**Agenda**  
**Planning Commission**  
**Council Chambers**  
**Wednesday, October 19, 2016 – 7:00 P.M.**

**Staff Review of Special Nonconforming Use Application  
1007-1009 Grant St. Duplex-Nonconforming A  
1007-1009 Grant St.**

**Staff Review of Planned Unit Development (PUD)  
Firehouse Storage and Townhomes  
298 Jarvis**

SHEET + NUMBER  
**SP1.00**

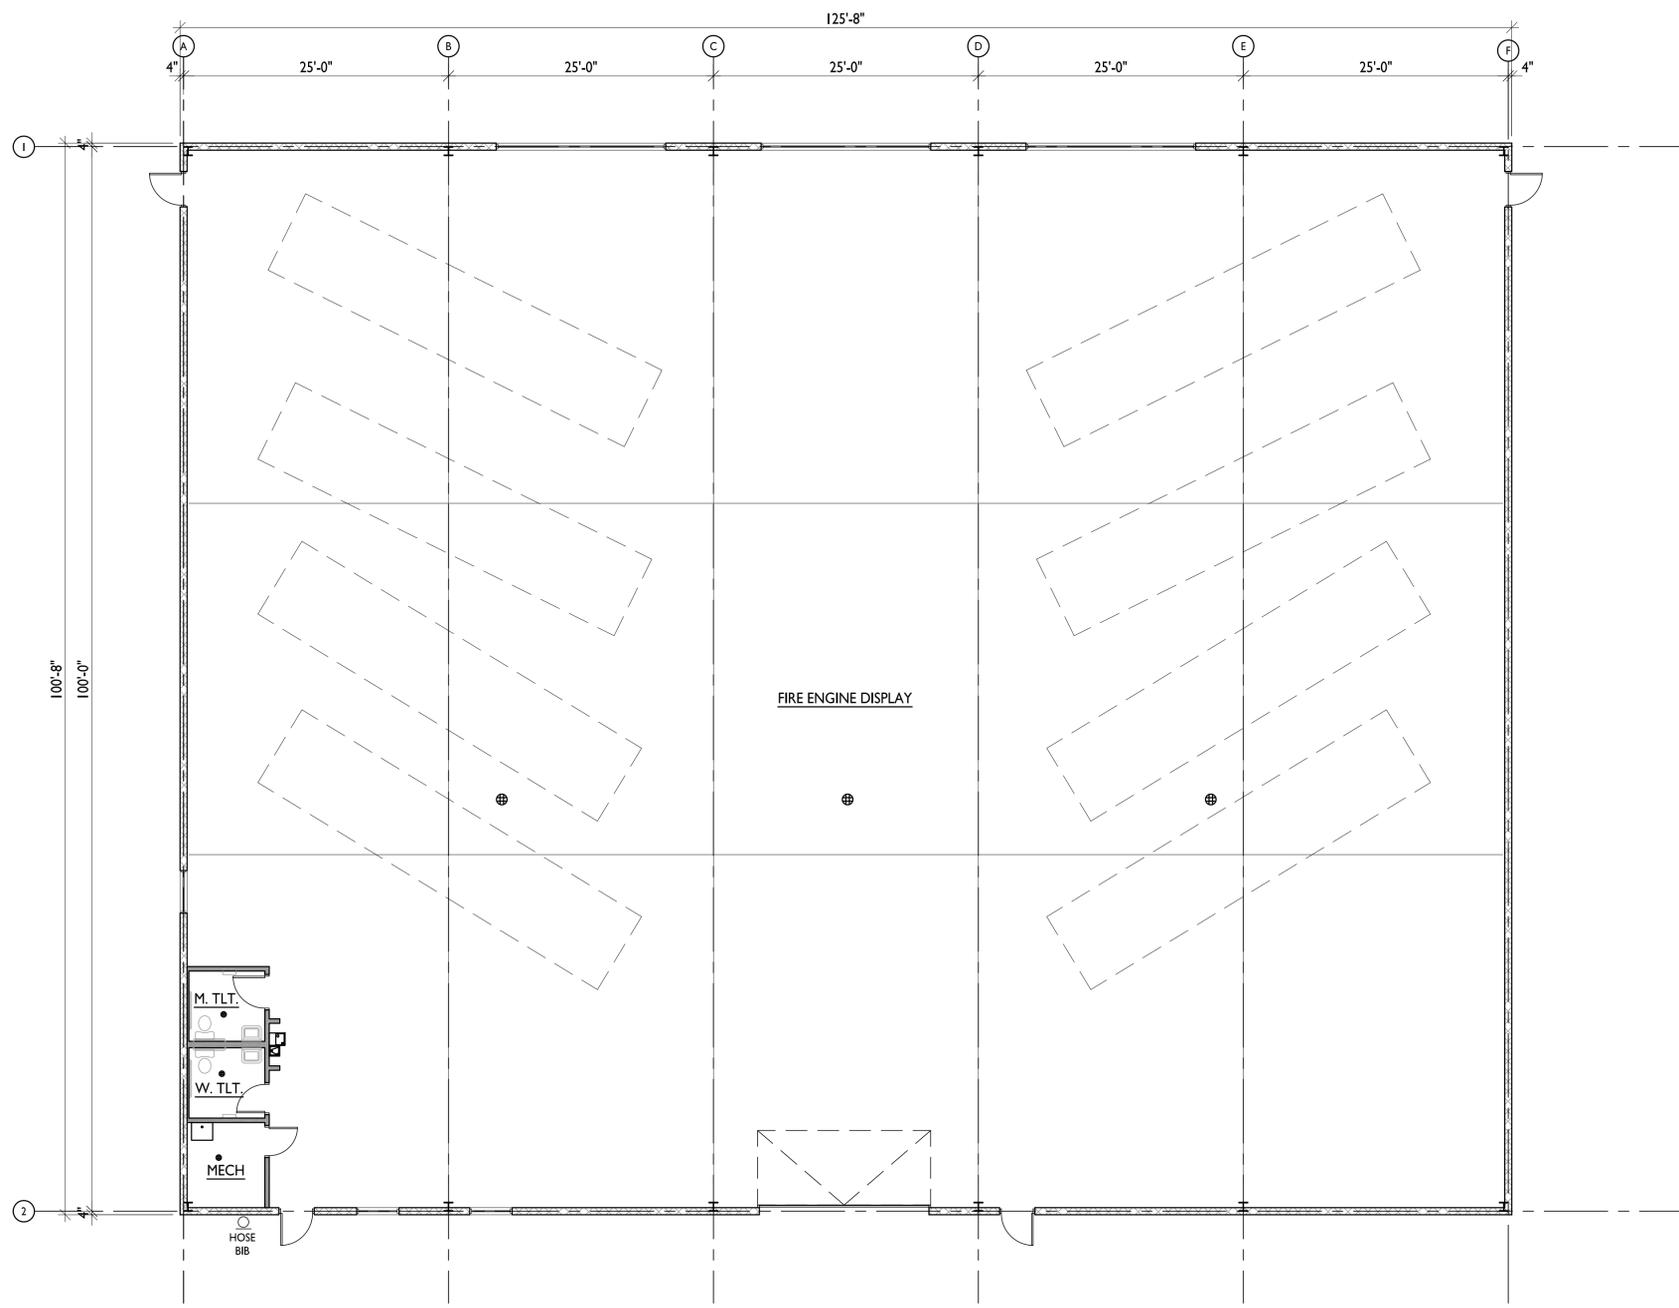
1. Provide marked or raised path for pedestrians to/from parking areas.
2. **No lighting levels or fixtures are indicated on lighting plan for front of townhomes, yet fixtures shown in elevation; provide additional detail.**
3. Waiver requested from strict application of 122-703 due to the wall face having no windows and the use being low-intensity; with a finding that the benefit intended to be secured will exist without the required screening.
4. Screen the parking north of the townhomes from the Huron Rive Drive frontage in accordance with 122-835(11)(c)
5. Provide at least three bicycle parking spaces for the site.
6. Increase width of shared-use path on Huron River Drive frontage to 10'.

1. Provide marked or raised path for pedestrians to/from parking areas.
2. Provide additional detail on lighting levels and fixtures for front of townhomes in accordance with §122-641.

3. Screen the parking north of the townhomes from the Huron Rive Drive frontage in accordance with §122-835(11)(c).
4. Provide at least three bicycle parking spaces for the site.

SHEET  
Utility Plan

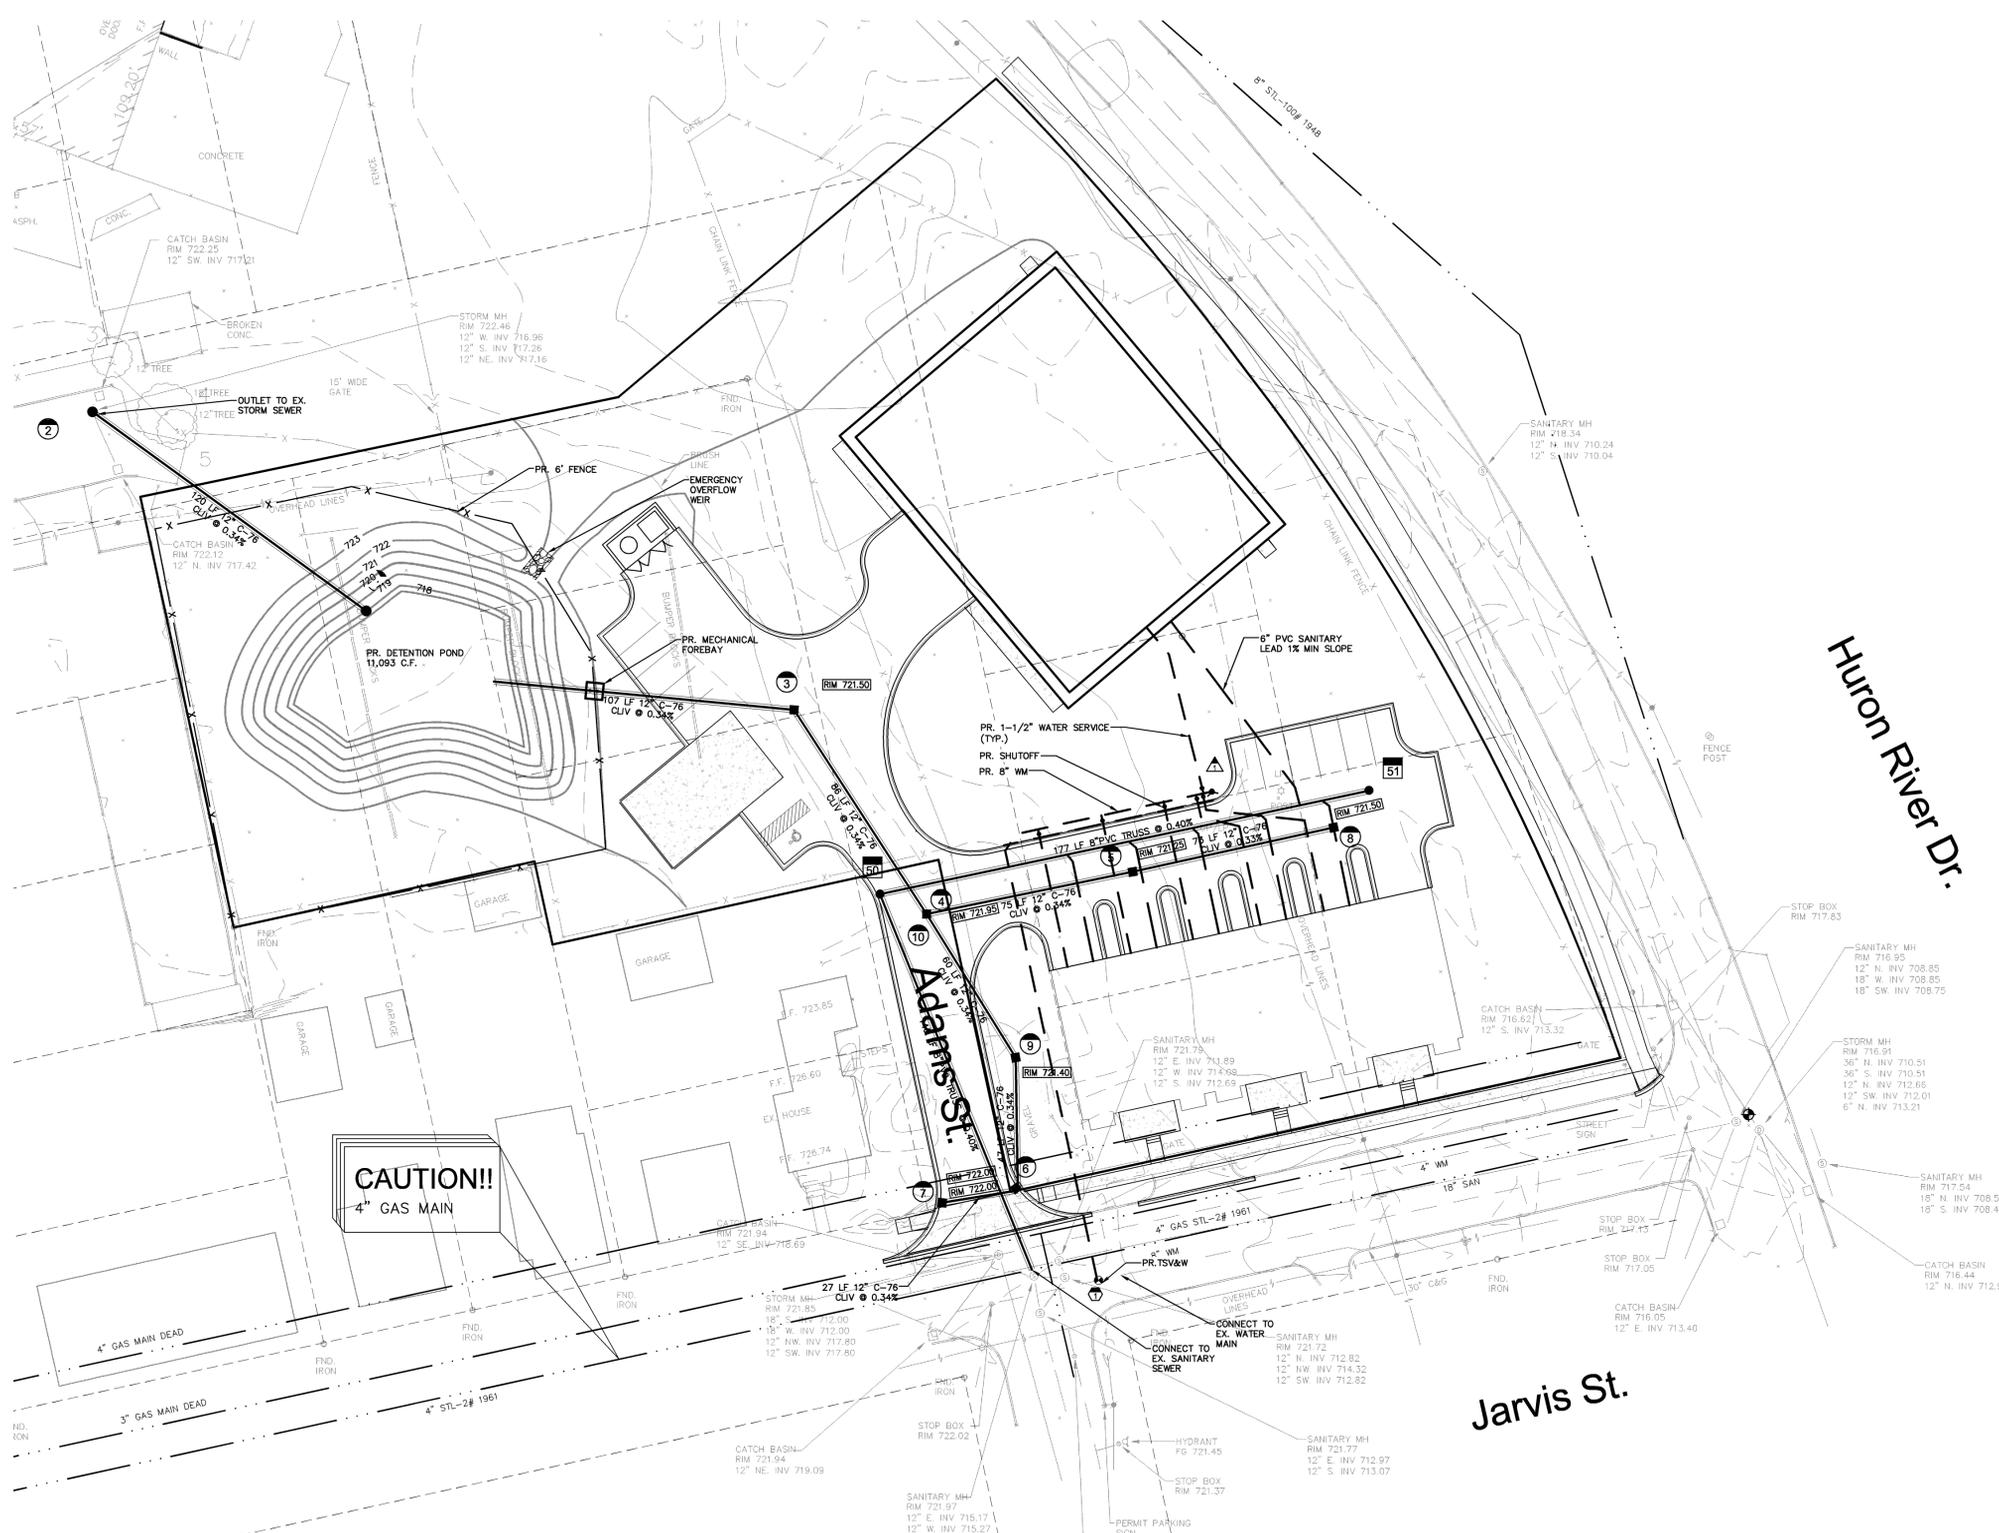
right-of-way. The commercial building can connect to the sanitary sewer in Huron River Drive. As part of the project, the existing 10" diameter water main in the Huron River Drive right-of-way needs to be replaced with a new 12" diameter water main from Jarvis to the north property line of the subject parcel and the commercial building connected to the new water main. I believe the cost of the 12" water main will be about the same as the cost of the proposed water main and sanitary sewer mains currently shown on the plans."

1. Connect to existing sanitary sewer in Huron River Drive ROW.
2. For water infrastructure, replace the existing 10" main in the Huron River Drive ROW from Jarvis to the north property line with a 12" main, and connect to the new 12" main.

8. The storage building must connect to existing sanitary sewer in Huron River Drive ROW.
9. For water service for the storage facility, replace the existing 10" main in the Huron River Drive ROW from Jarvis to the north property line with a 12" main, and connect to the new 12" main.

PRELIMINARY LANDSCAPE PLAN  
SCALE: 1" = 30'

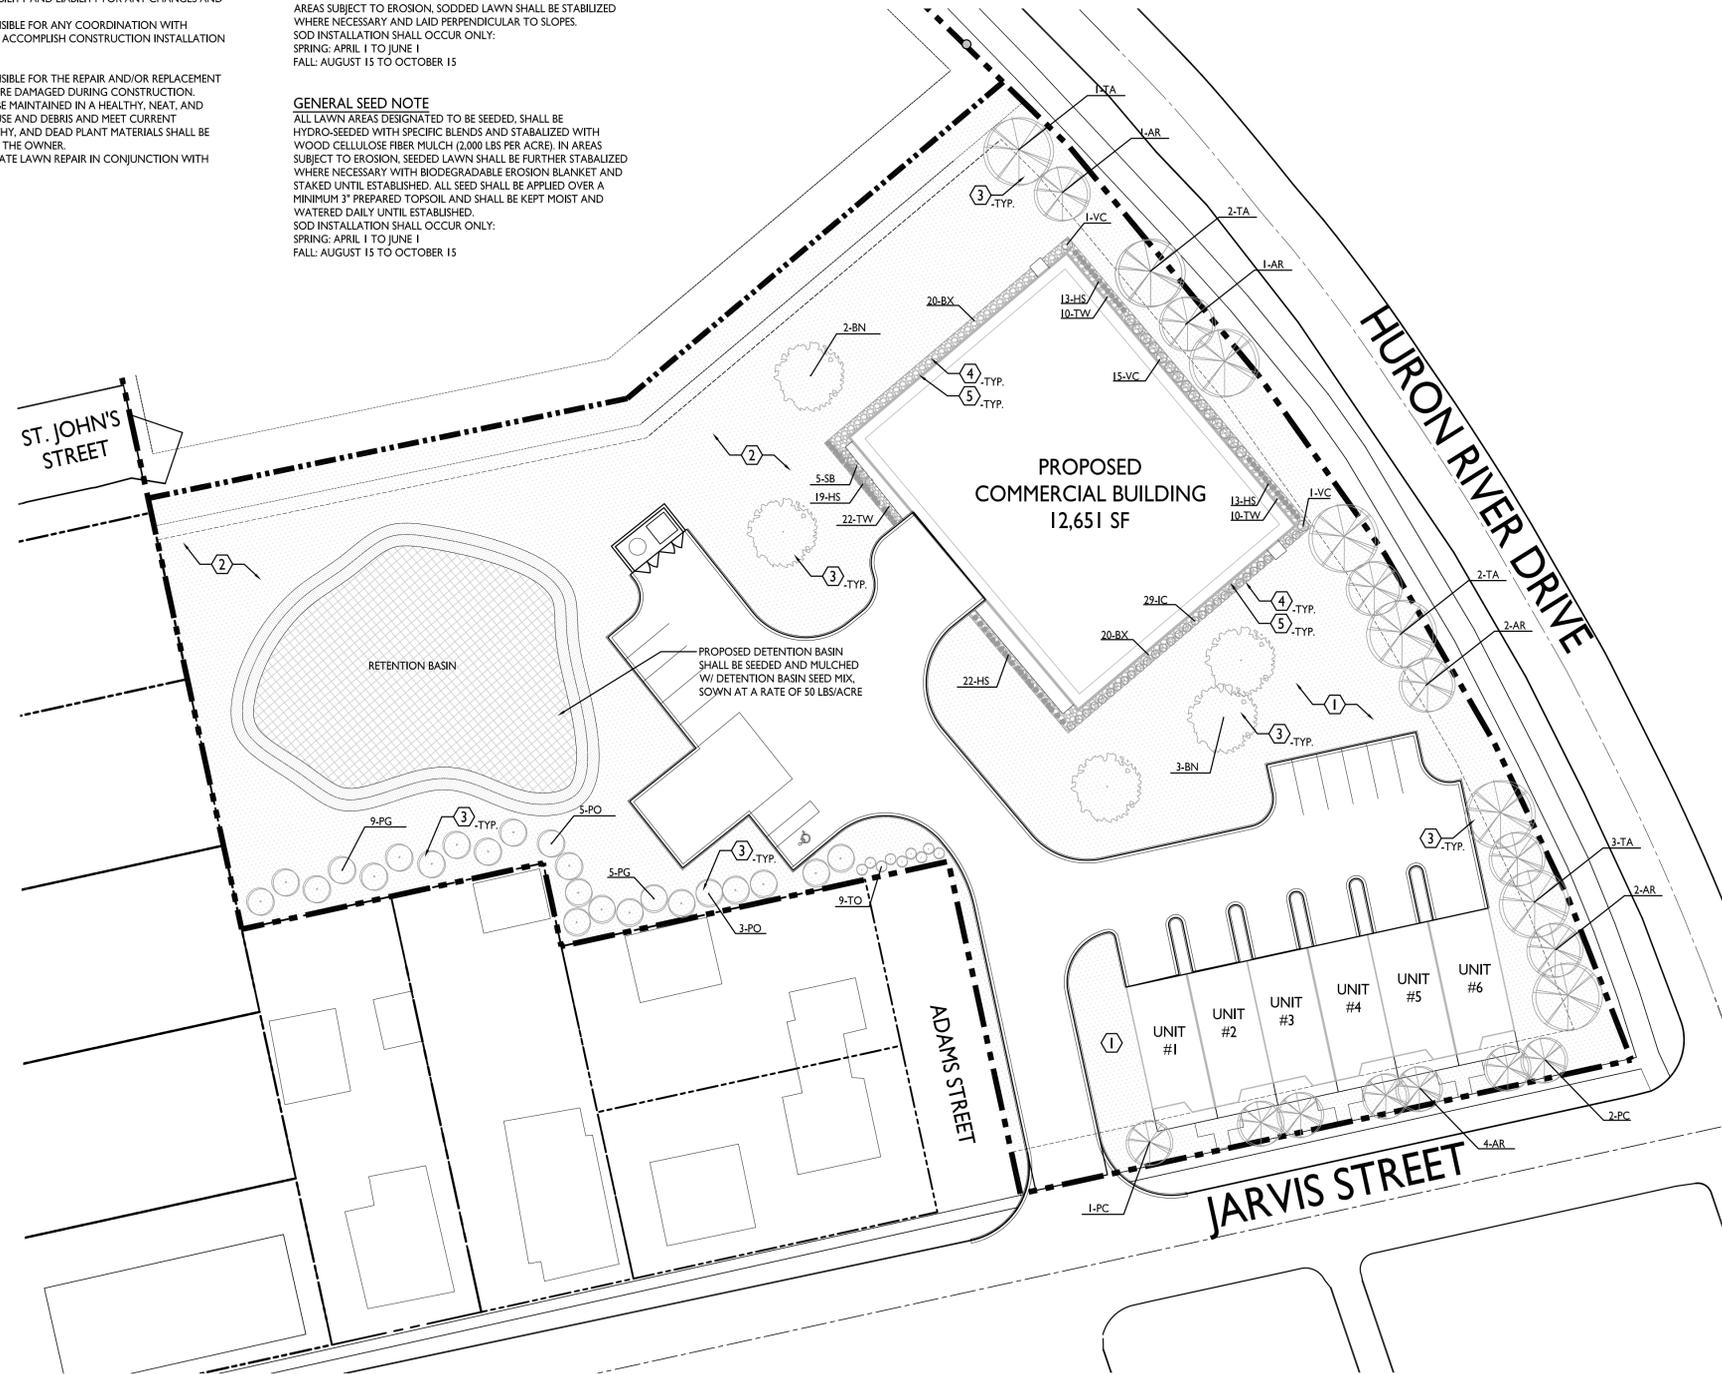
1. Provide data for lighting at Jarvis Street frontage of townhomes.
2. Clarify anticipated usage of the masonry enclosure: only for storage facility, or also for residential?
3. Waiver requested from strict application of 122-703 due to the wall face having no windows and the use being low-intensity; with a finding that the benefit intended to be secured will exist without the required screening.
4. No street trees have been provided in the right-of-way. Stagger trees shown in the front yards to either side of the sidewalk & border-to-border trail.
5. Note watering or maintenance plan for landscaping on the landscaping plan.

10. Clarify anticipated usage of the masonry rubbish enclosure: only for storage facility, or also for residential?
11. No street trees have been provided in the right-of-way. Stagger trees shown in the front yards to either side of the sidewalk & border-to-border trail.

12. Note watering or maintenance plan for landscaping on the landscaping plan.
